Docket Number:	06-AFC-09C
Project Title:	Colusa Generating Station - Compliance
TN #:	217513
Document Title:	Notice of Determination Petition to Amend Colusa Generating Station
Description:	Notice of Determination
Filer:	Raquel Rodriguez
Organization:	California Energy Commission
Submitter Role:	Commission Staff
Submission Date:	5/9/2017 3:39:03 PM
Docketed Date:	5/9/2017

**NOTICE OF DETERMINATION
PETITION TO AMEND
COLUSA GENERATING STATION
(06-AFC-09C)**

The amendment is seeking approval to modify the CGS by installing rotating intake screens to control algae blooms at the water intakes for the Tehama Colusa Canal (TCC), and associated equipment at the TCC pump. The TCC is owned by the U.S. Bureau of Reclamation and operated by the Tehama Colusa Canal Authority. The proposed project modification would eliminate the need for the routine manual cleanup of the large algae blooms that build up near the pump intake screens.

ENVIRONMENTAL JUSTICE POPULATION FIGURE
Colusa Generating Station - Environmental Justice Population Figure

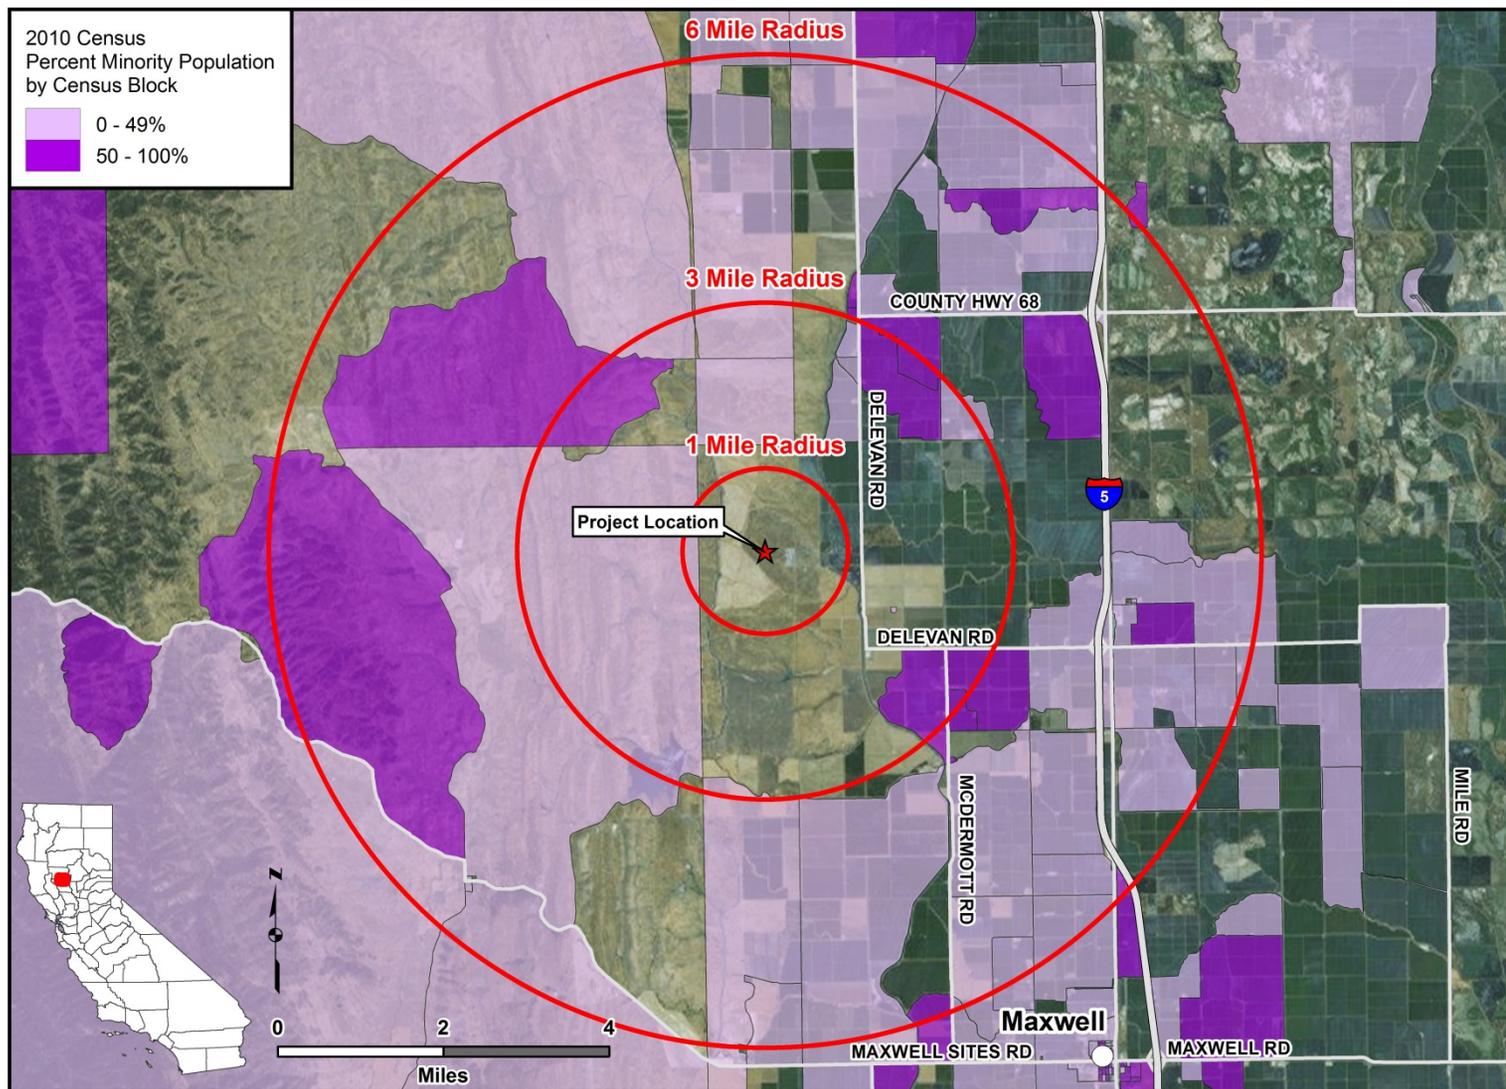
The **Environmental Justice Population Figure** (attached) shows 2010 census blocks in the six-mile radius of the CGS with a minority population greater than or equal to 50 percent. The population in these census blocks represents an EJ population based on race and ethnicity as defined in the United States Environmental Protection Agency's *Guidance on Considering Environmental Justice During the Development of Regulatory Actions*.

Staff has determined that the impacts of the proposed modifications would be less than significant or less than significant with implementation of existing conditions of certification. Therefore, impacts would be less than significant for any population in the project's six-mile radius, including the EJ population represented in the **Environmental Justice Population Figure**.
